CHANGE ORDER

PROJECT : Mt. Gilead Road Bike/Pedestrian Trail

Description : Continue the 6' wide sidewalk north along Roanoke road from
current project limits to the driveway for 1447 Roanoke Road
Furnish all materials and labor to complete the sidewalk
and required grading

CONSTRUCTION PLANS FOR SIDEWALK ADDITIONS ROANOKE ROAD

SIDEWALK PLAN & PROFILE
BEGIN TO STA. 4+00

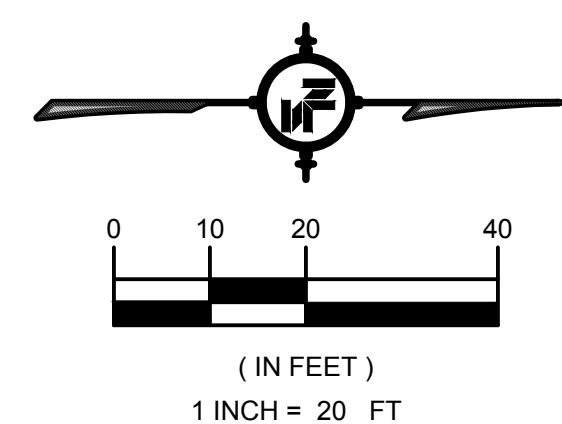
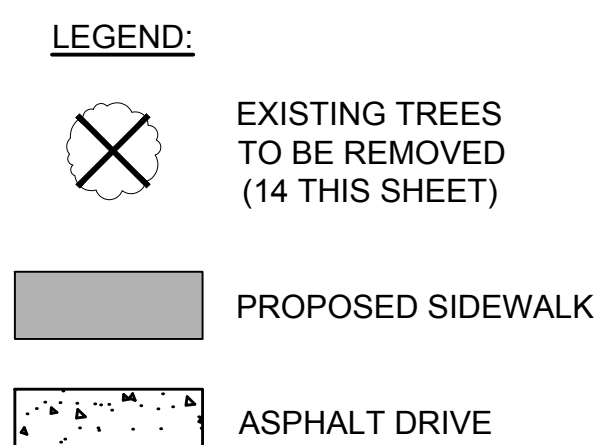
Purpose of Change Order : To continue the sidewalk north on Roanoke road and
connect to recently completed Overton Ridge Park
providing increased pedestrian amenities in the area
